GENERAL MOTORS NORTH AMERICA
Structure & Safety Integration

The following information is submitted pursuant to the requirements of 49 CFR 573.5 as it applies to a determination by General Motors of a safety defect involving certain 2003 model year 2500 Series Chevrolet Avalanche and Suburban, and GMC Yukon XL vehicles.

SUBJECT: 03002 – MID-FRAME CROSS MEMBER TEAR

MODELS: 2003 CHEVROLET 2500 SERIES AVALANCHE, SUBURBAN
2003 GMC 2500 SERIES YUKON XL

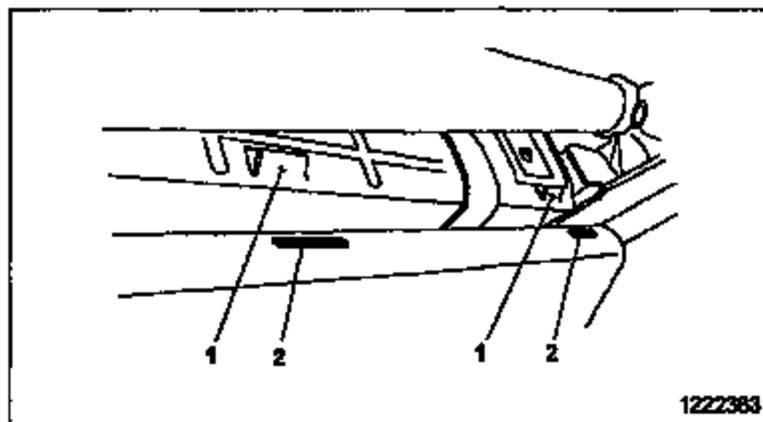
The illustration below shows the shield being positioned under the fuel tank prior to attachment. Only two of the three slots (2) and tabs (1) are shown. The third slot and tab are located further to the rear of the shield.

3. Raise or lower the shield as necessary to hook the slots (2) located along the inboard edge of the shield onto the three metal tabs (1) located on the inboard side of the fuel tank.
4. Raise the outboard side of the shield up to the bottom of the left frame rail and support in place.
5. To attach the shield, install the three bolts through the holes in the shield and into the EXISTING holes in the BOTTOM of the frame rail. Tighten to 12 Nm (106 lb in).
6. Lower the vehicle as necessary to install the fourth bolt through the rear hole in the shield and into the existing hole in the outboard side of the frame rail behind the left rear tire. Tighten to 12 Nm (106 lb in).
7. Lower the vehicle.
8. Install the GM Recall Identification Label.
